EPC STORMWATER REVIEW COMMENTS
IN ORANGE BOXES WITH BLACK TEXT

Landscape Endeavors Building Addition

Commercial Construction Drawings

Landscape Endeavors Building Addition
CES Endeavors, LLC
Civil Site Plan
El Paso County, Colorado

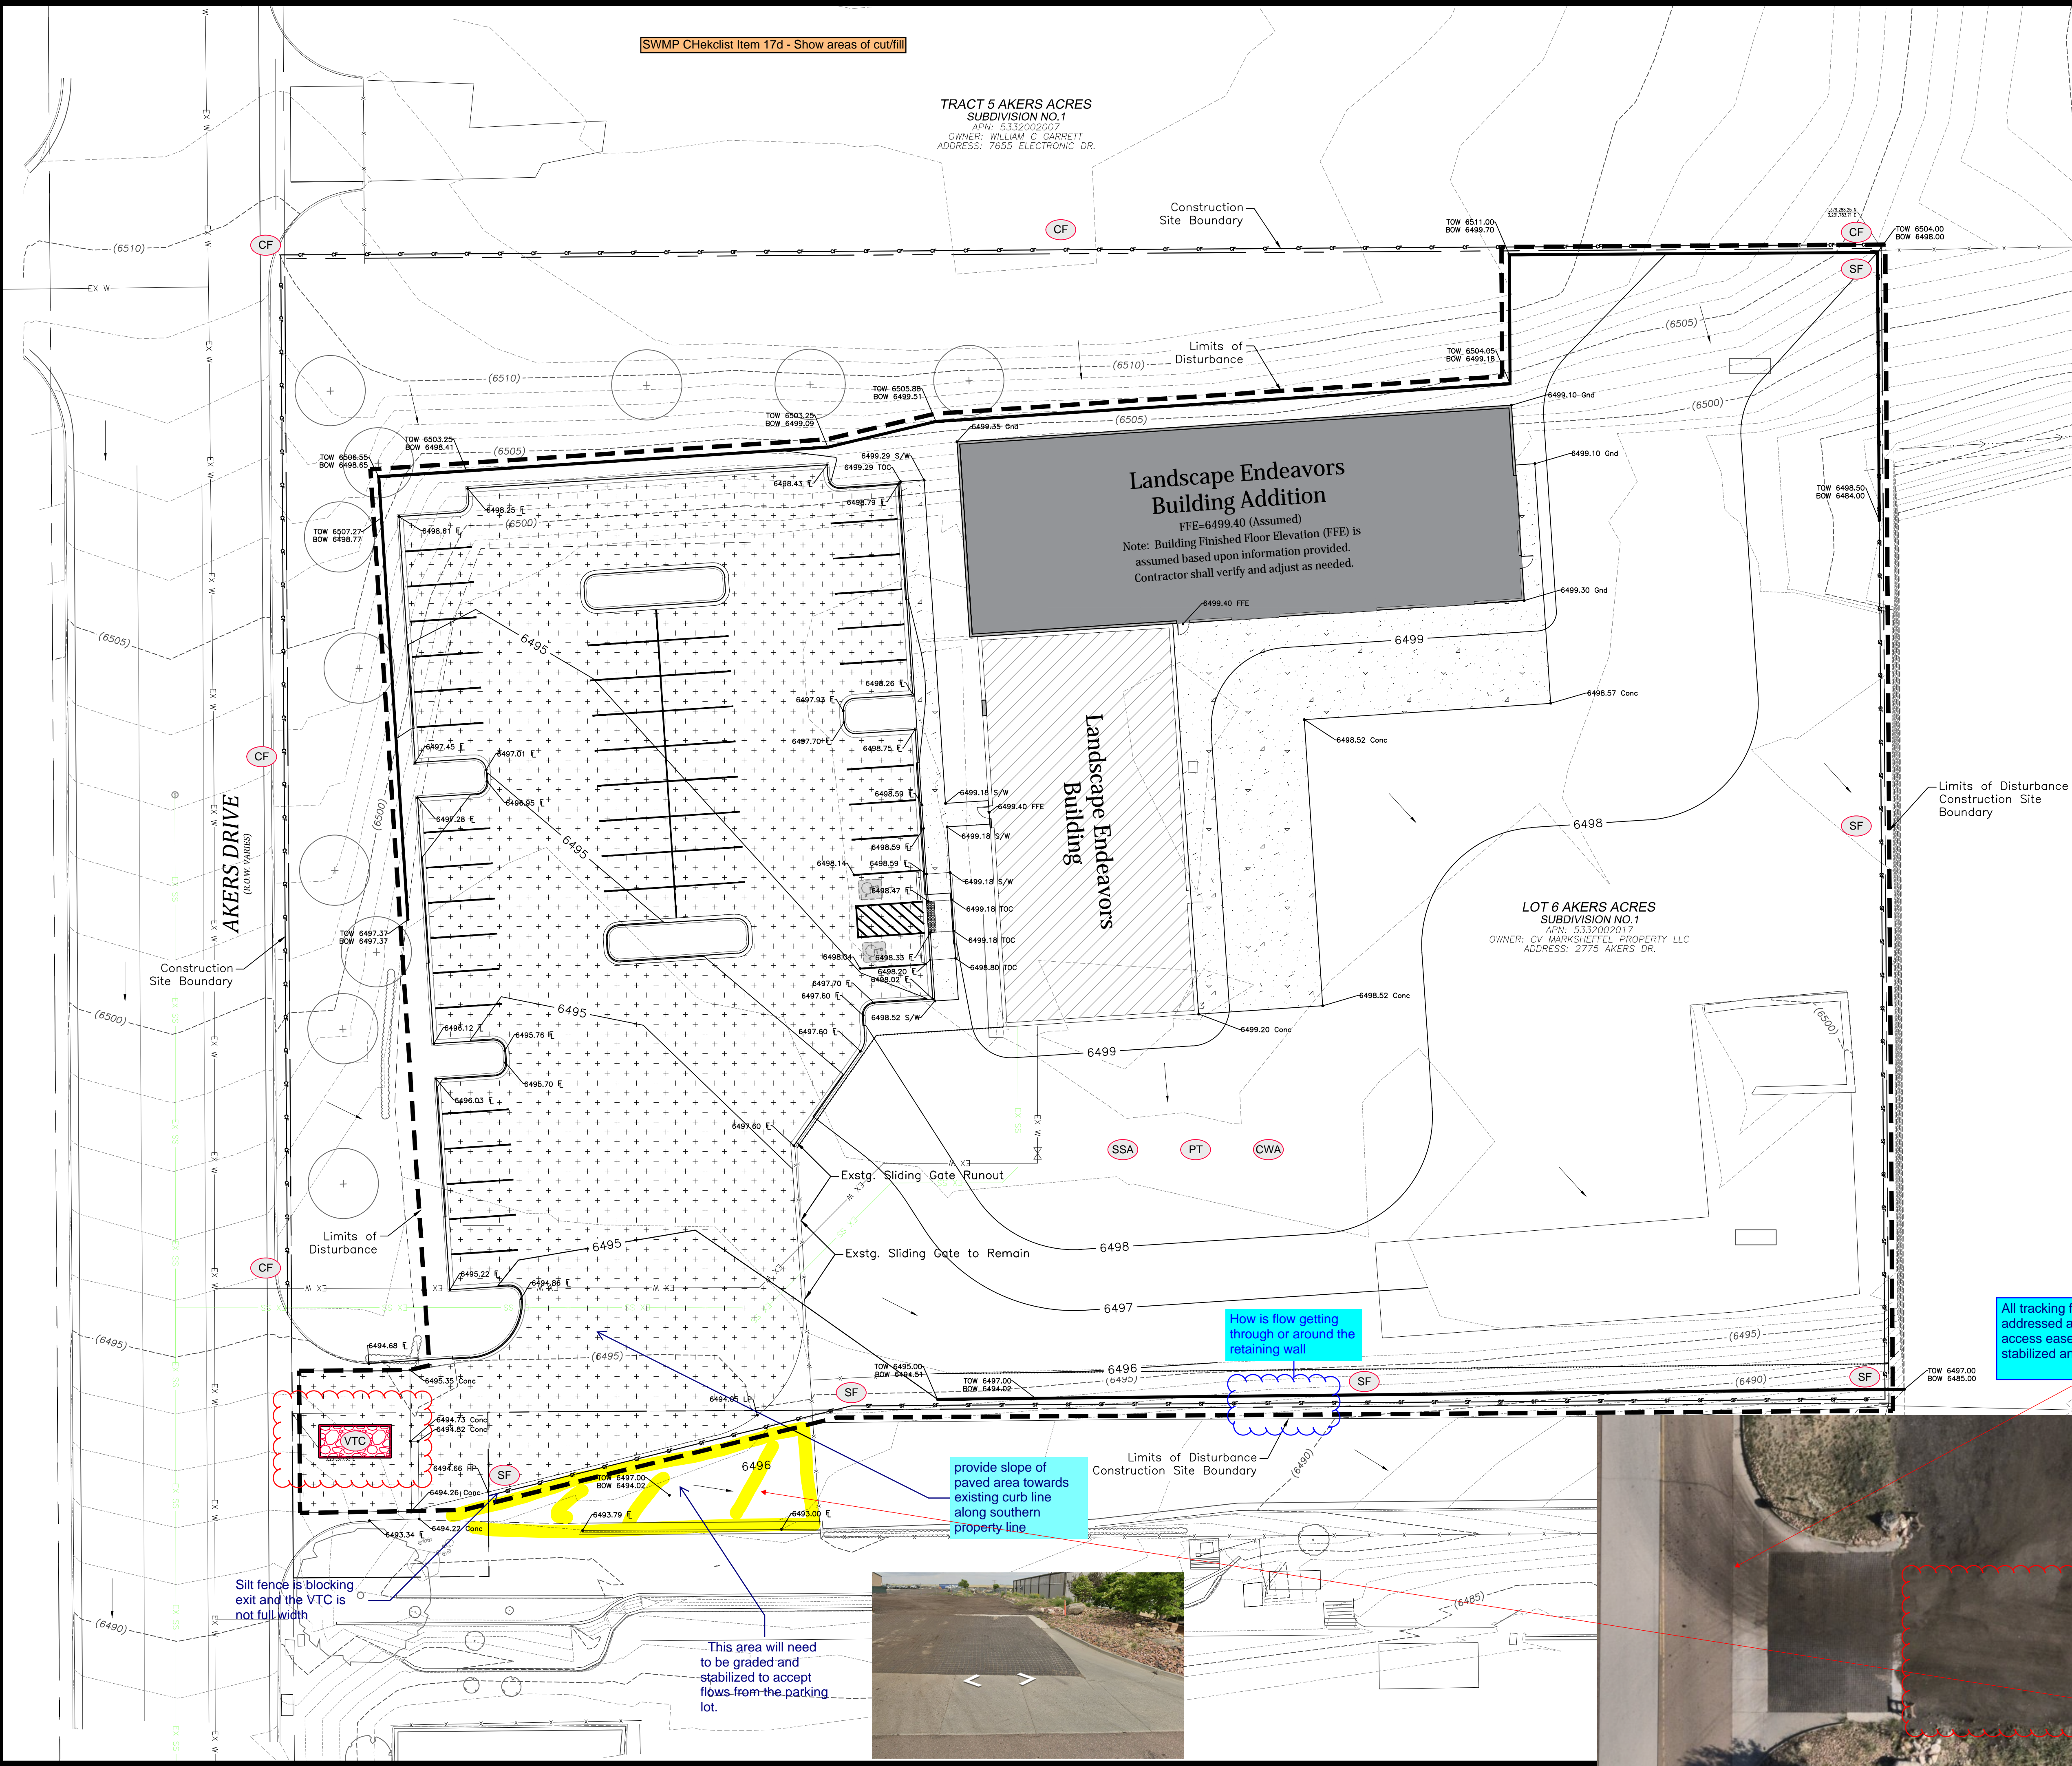
How is flow getting through or around the retaining wall

All tracking from the site must be addressed and mitigated. The shared access easement driveway must be stabilized and proper groundcover used.

provide slope of paved area towards existing curb line along southern property line

Silt fence is blocking exit and the VTC is not full width

This area will need to be graded and stabilized to accept flows from the parking lot.

Landscape Endeavors Building Addition
CES Endeavors, LLC
Grading and Erosion Control - Final Conditions
El Paso County, Colorado

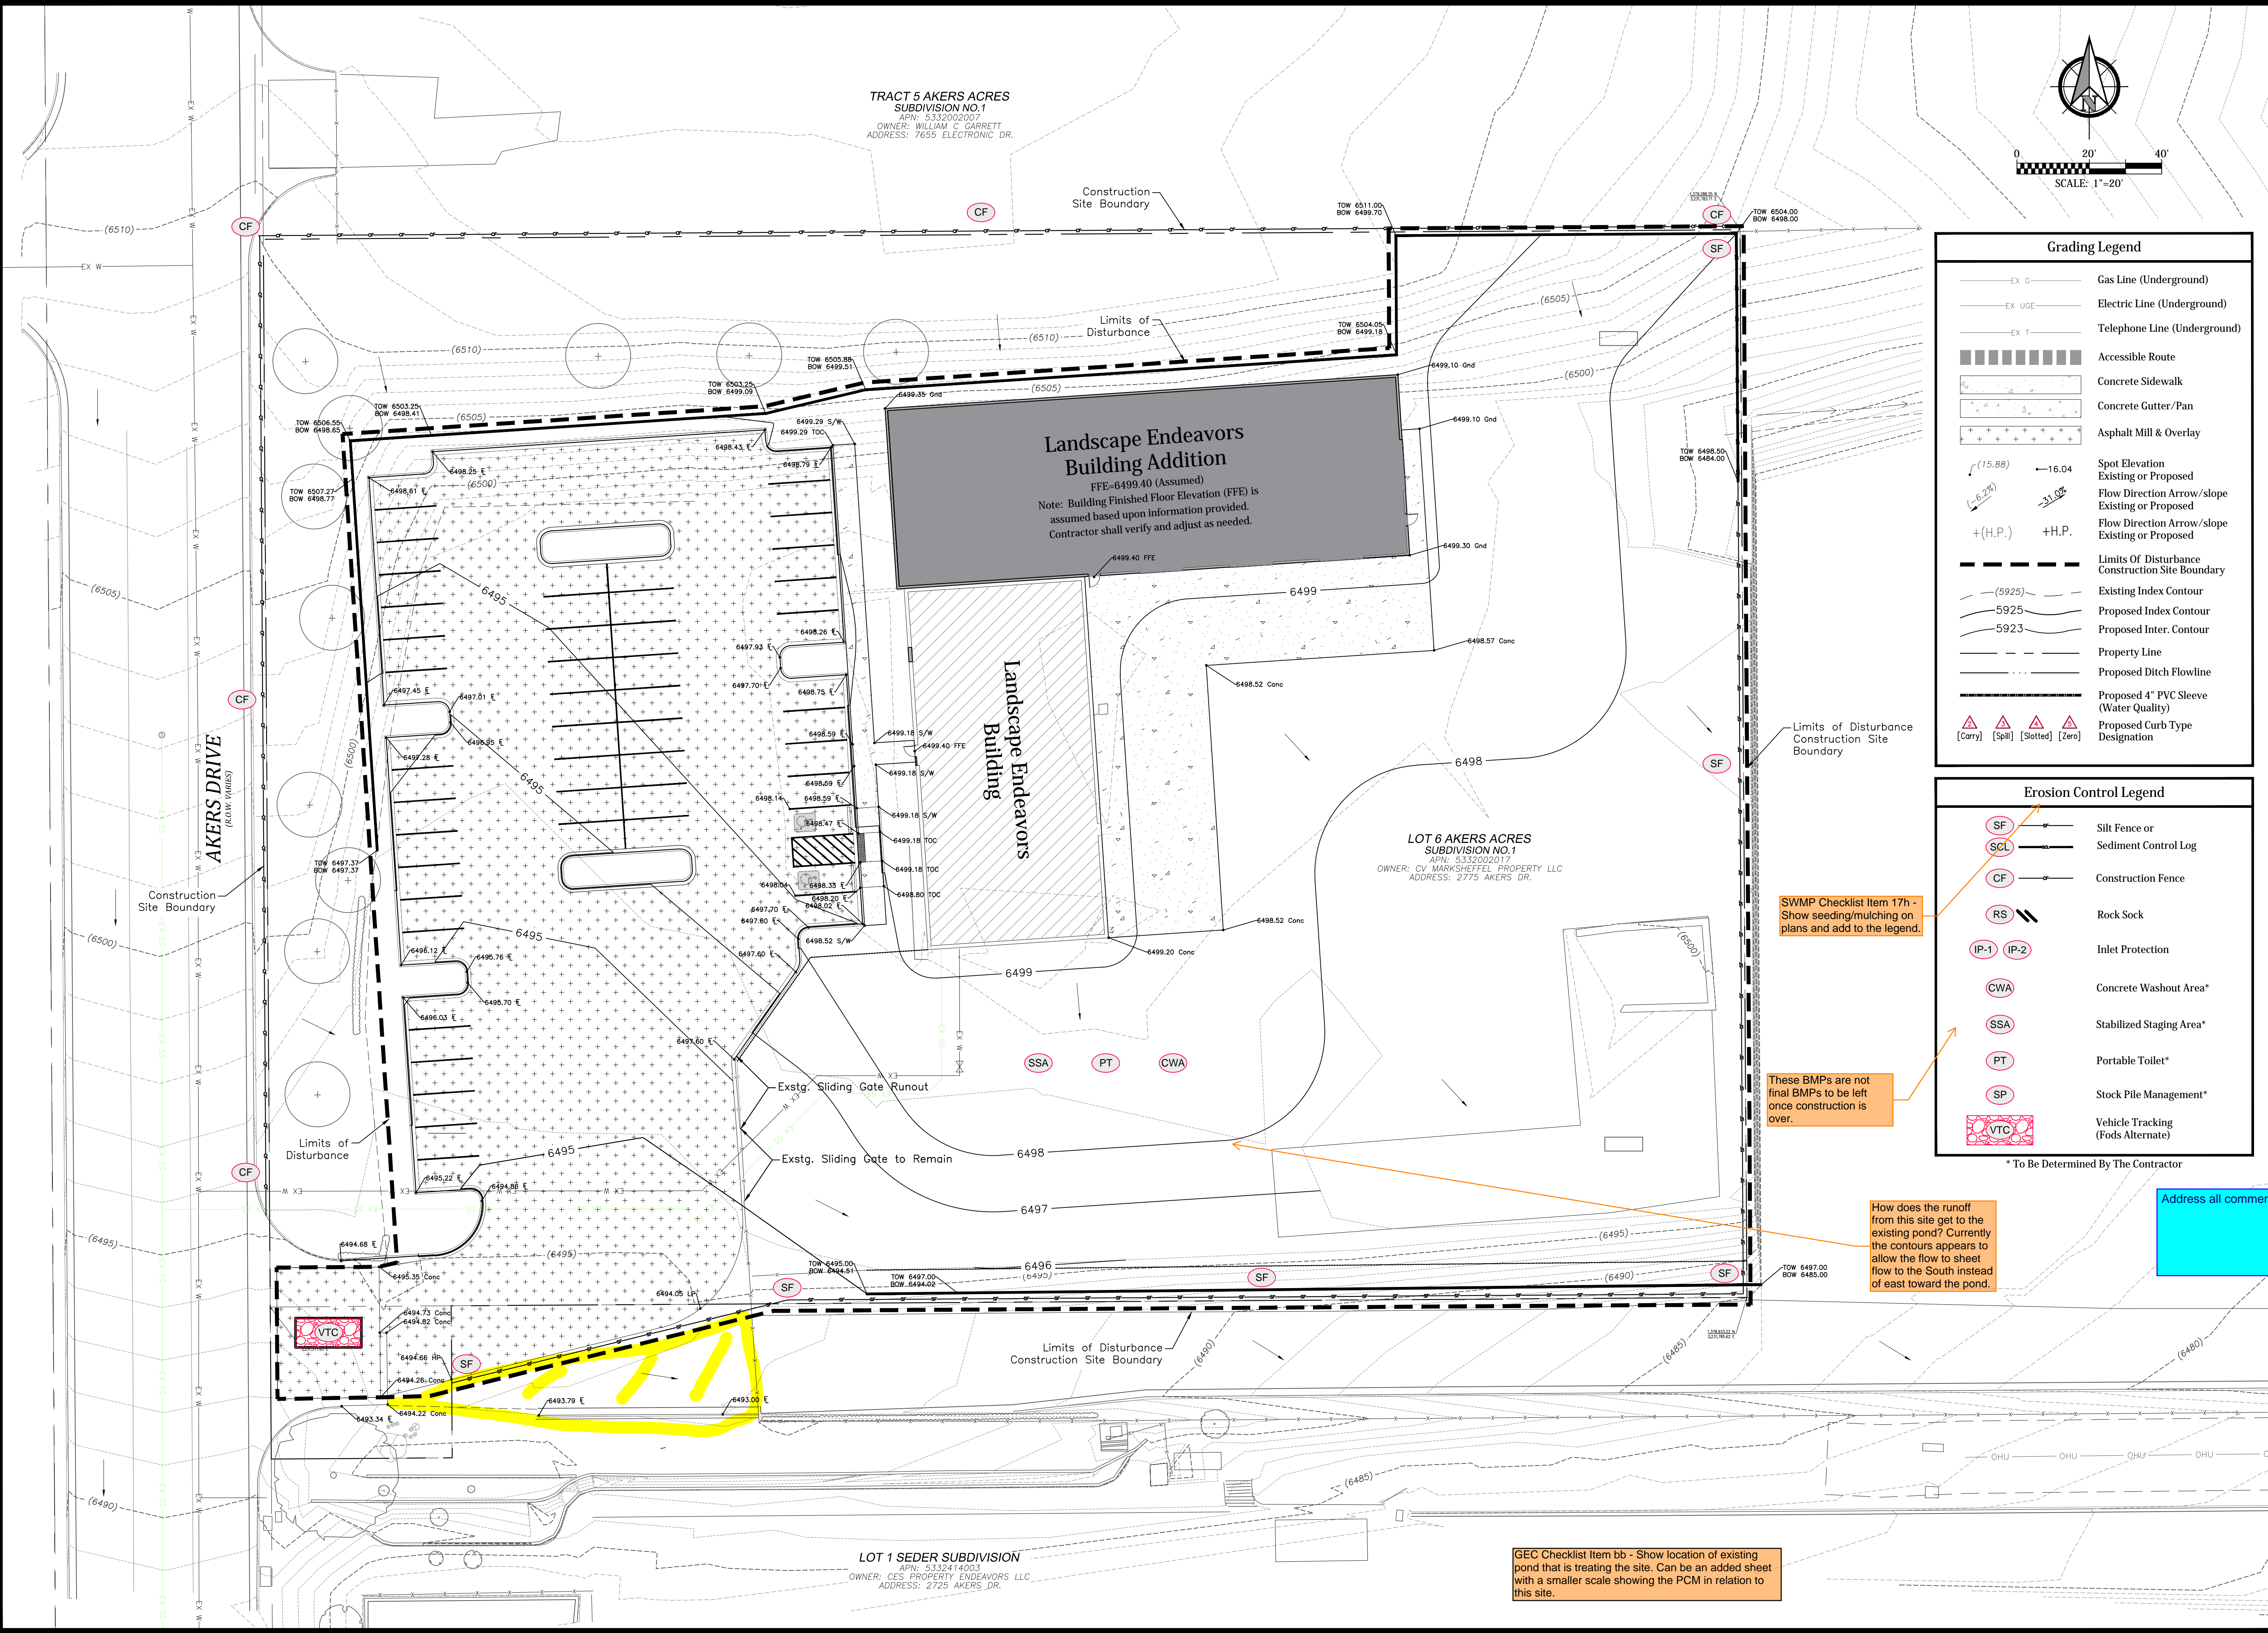
SWMP Checklist Item 17h - Show seeding/mulching on plans and add to the legend.

How does the runoff from this site get to the existing pond? Currently the contours appears to allow the flow to sheet flow to the South instead of east toward the pond.

Address all comments on sheet sheet C302

GEC Checklist Item bb - Show location of existing pond that is treating the site. Can be an added sheet with a smaller scale showing the PCM in relation to this site.
